SAFETY NOTICE

08-597-11

MODELS AFFECTED: HR37/40 Aerials

SUBJECT: *Boom lift cylinder 437250 with s/n codes D or W*

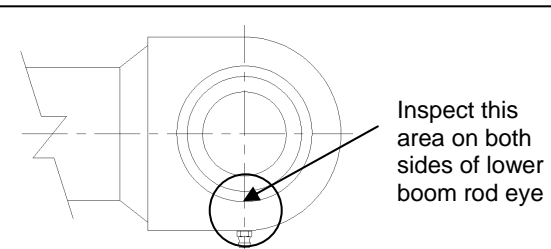
Terex Utilities has determined that some rod eyes on some 437250 lower boom lift cylinders are not to specification and can fail. The supplier involved provided cylinders used on HR37M and HR40M units that were built between November 2000 through December 2001 with cylinder serial numbers starting with D or W and followed by 5 or 7 numbers. **If the cylinder rod eye fails the boom and platform may fall.**

Inspect Lift cylinder rod end in this area on both sides. Clean off dirt and grease to see side of rod eye down into the bushing bore.

The owner, or user, must immediately verify if the lower boom lift cylinder on their unit has a serial number starting with D or W by looking on the ID tag near the base end on the cylinder case. If it does not have a serial number starting with D or W, the unit is not involved with this Safety Notice. If it does have a serial number beginning with D or W, perform a visual inspection of the cylinder rod eye in the area of the grease zerk (see figure below). Clean off the dirt and grease to determine if a crack is evident near the ball bushing. If there is any indication of a crack immediately remove the unit from service and contact Terex Utilities at 605-884-3892. If no crack is detected arrange inspection by calling 605-884-3892, or sending a fax to 605-882-5572, or sending an email with the machine information to utilities.warranty@terex.com or by contacting the nearest Terex Utilities dealer within 45 days. You may continue to use the unit if you inspect the rod eye daily and verify that no cracks are present.

Affected units, as shown on the owner letter, of part number 437250 and the date codes D or W will have the cylinder rod inspected at no charge to the owner. If the material is not to specification the cylinder rod will be replaced at no charge to the owner.
